LINCOLN PARK PLANNING COMMISSION
CITY HALL – COUNCIL CHAMBERS
1355 SOUTHFIELD ROAD
LINCOLN PARK, MICHIGAN

City of Lincoln Park,
Wayne County, Michigan
SITE PLAN DOCUMENTS
Prepared For
White Castle Systems

Site Plan Review

Hennessey Engineers, Inc., completed our review of the Preliminary Plan based on the plan submittal date September 28, 2016, and received via email from you on October 14, 2016.

SHEET
General Site Plan

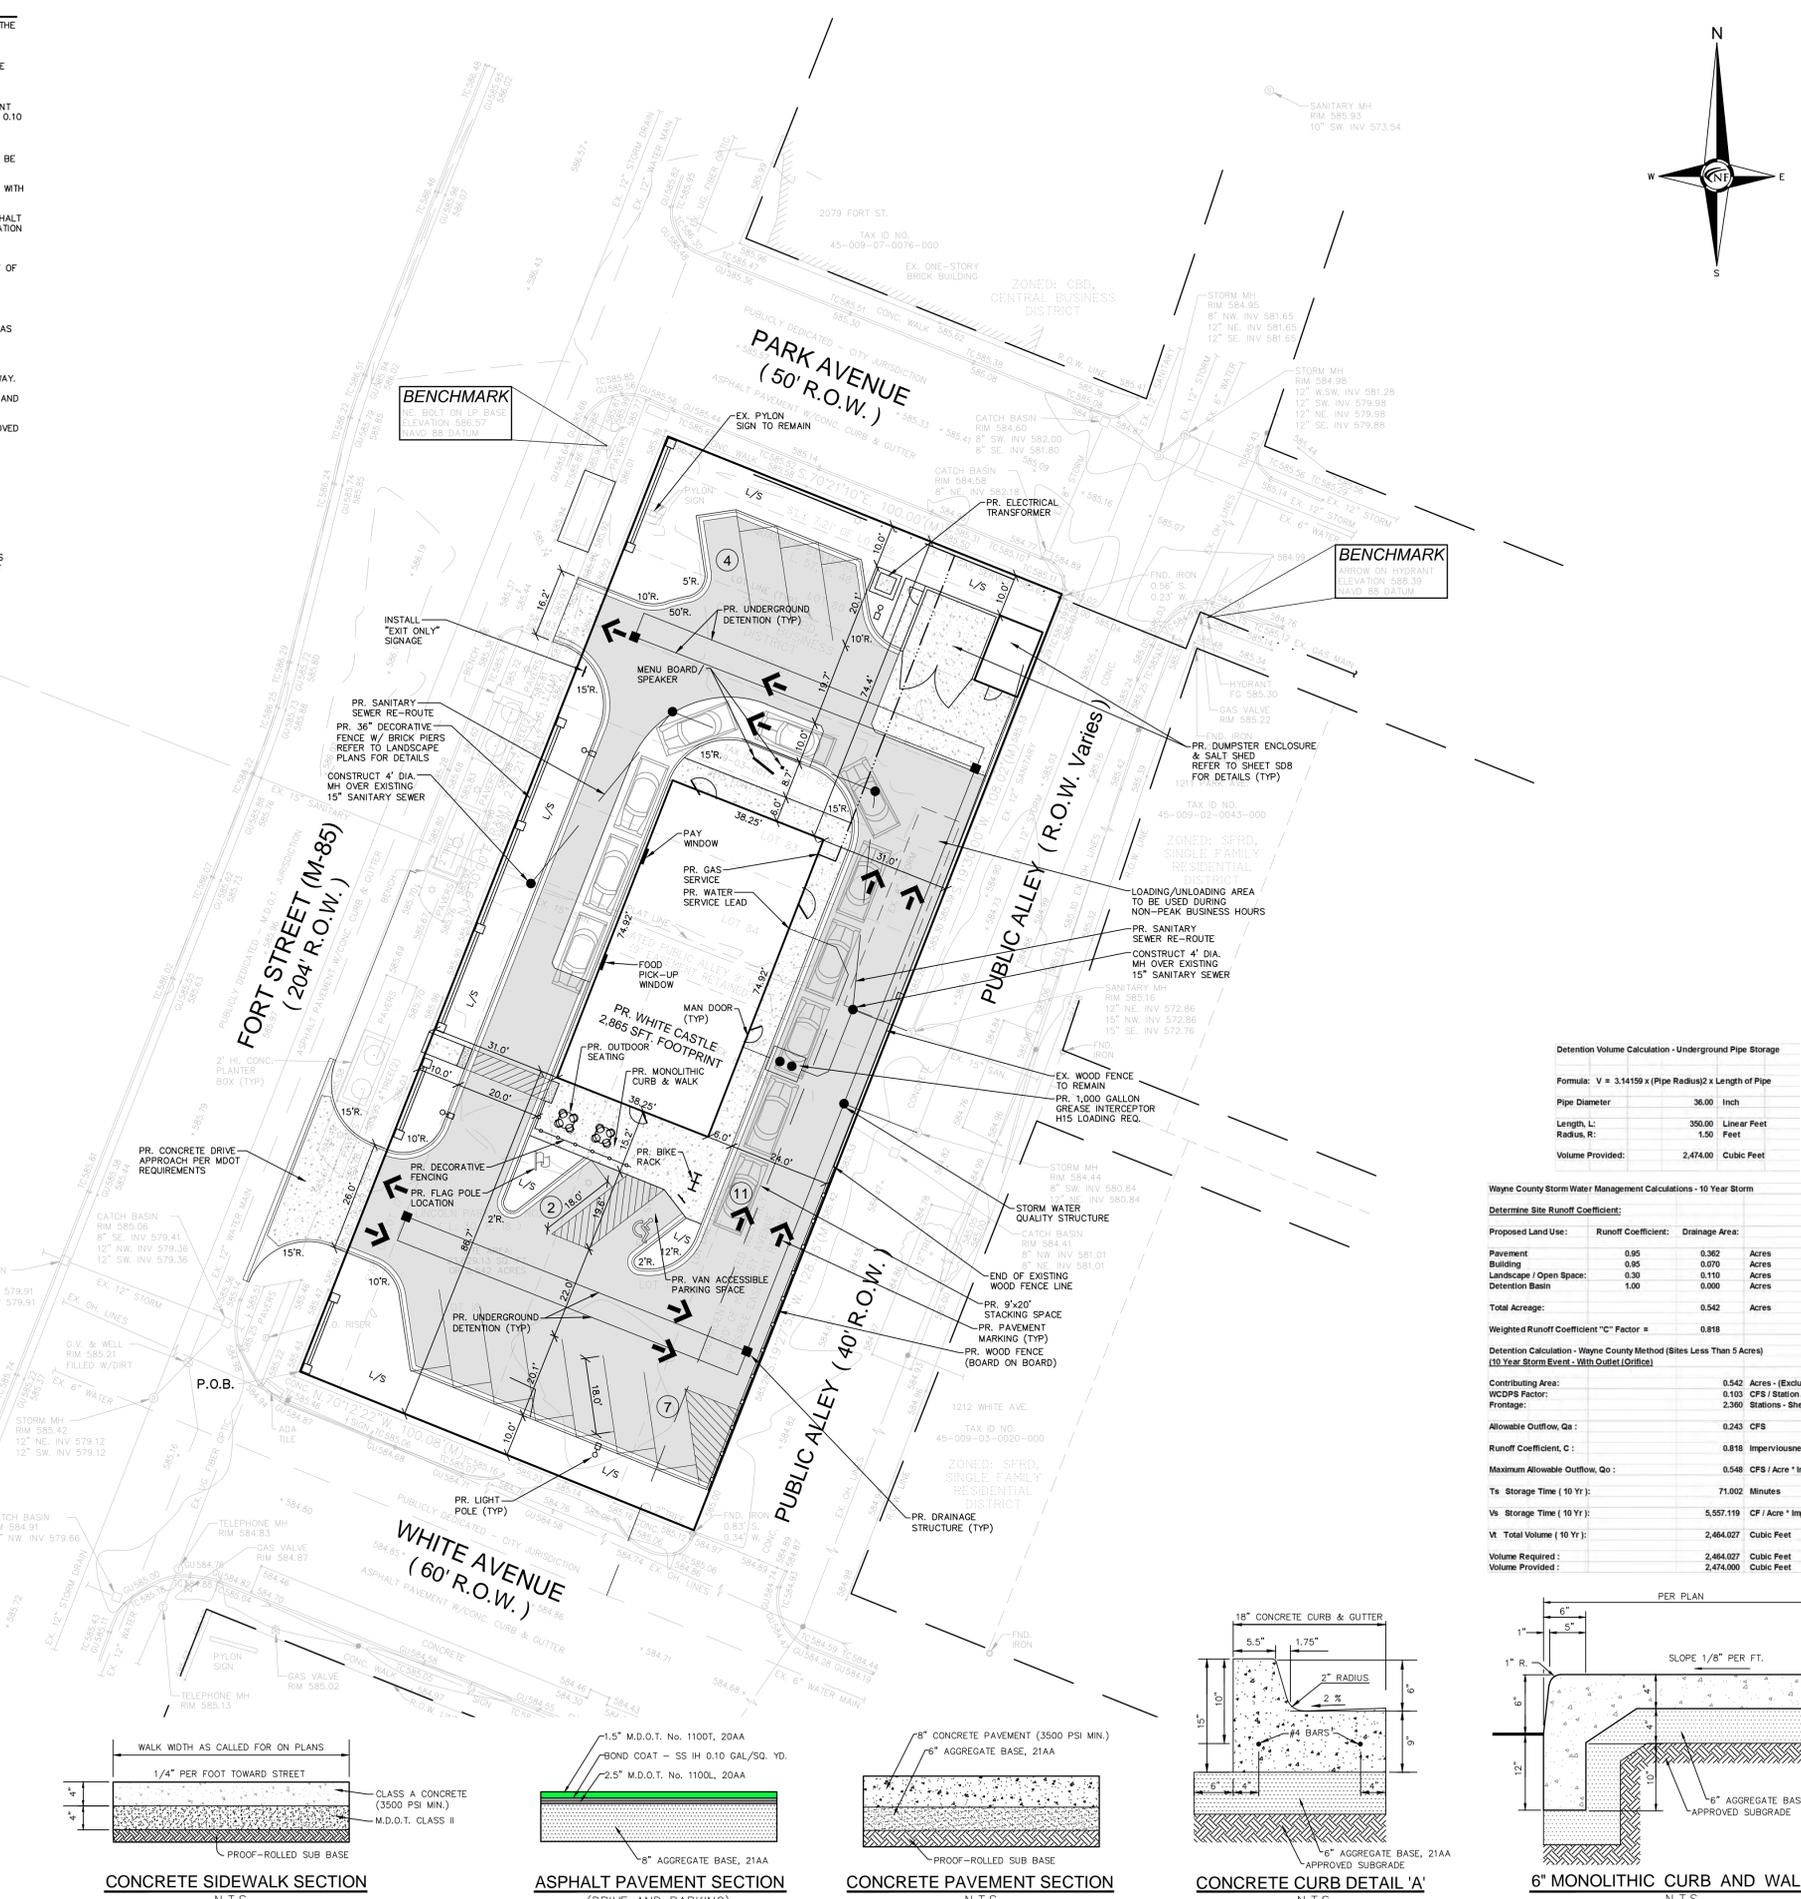
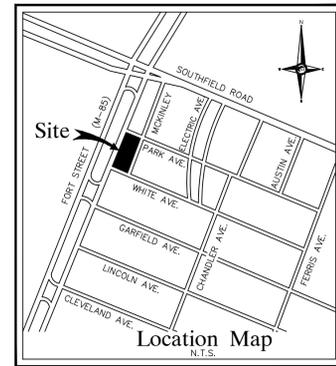
As proposed, this site design does not meet the access standards of section 1290.10. The biggest source of noncompliance is the north, exit-only driveway. The ordinance-driven solution is to locate the second driveway on Park Avenue, though this may no longer fit local preferences. The Planning Commission should discuss the available options and solutions with the applicant and, if necessary, the City Engineer and the Michigan Department of Transportation.

3. A site grading plan will need to be developed and approved by our office.
4. The plans are showing the sanitary sewer relocation around the building foot print which is a necessity. The size and slopes of the proposed sewer will need to be reviewed.

5. Show the percent slopes on the parking lot grades. For asphalt pavement the slopes should be a minimum of one percent.
6. Hennessey Engineers, Inc., will review the drainage and grading plan during the detailed engineering review.

Figure 1: Aerial View

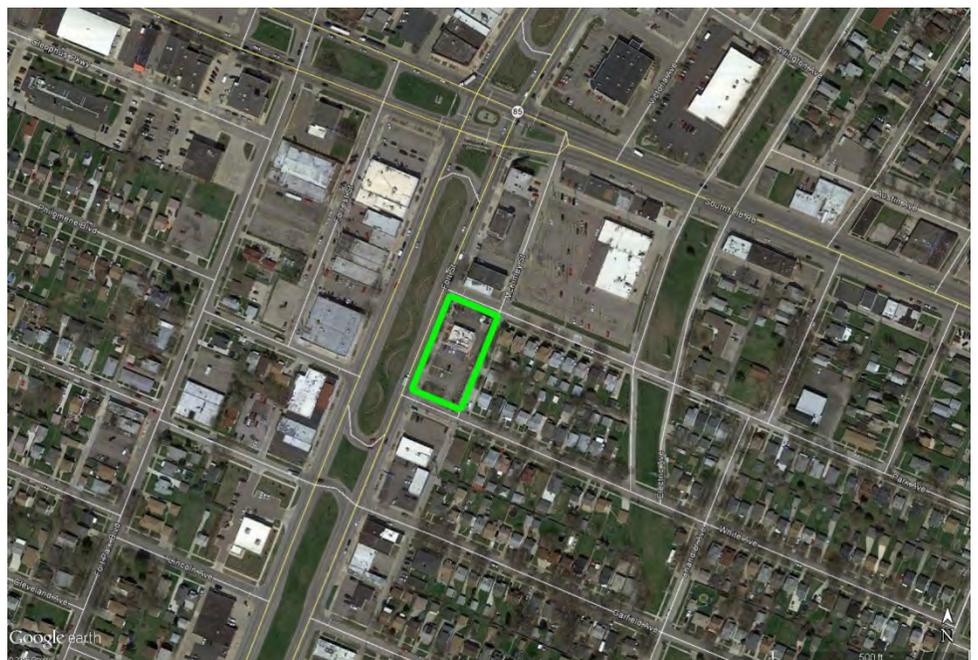
The project site is a long-standing White Castle restaurant located near City's major intersection and historic core. The applicant proposes to replace the existing 1900 sf White Castle restaurant building with a new building of approximately 2865 sf, adding 965 sf to the footprint. Parking, stacking, loading, and circulation have been modified to accommodate the expansion.

Figure 2: Zoning Map

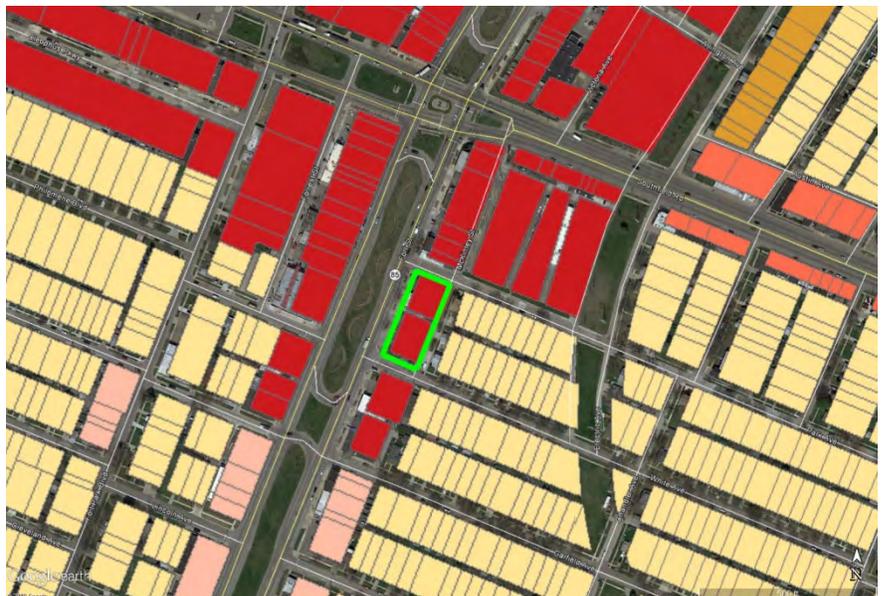
The site is zoned Central Business District (CBD), in which restaurants are a permitted use. However, drive-thru establishments are expressly *not* permitted in the CBD because the district regulations are designed to promote nonmotorized mobility; auto-oriented uses are considered more appropriate in other business districts. Due to the longevity of the business in the City and its popularity, the City wished to explore any mechanisms by which the proposed expansion could coexist with the desired emphasis on pedestrian and bicycle mobility throughout the district. A rezoning to a Planned Unit Development allows for the City and the applicant to negotiate a site design that retains this historic business within the City's core and also contributes to the walkable character that its citizens and leaders desire.
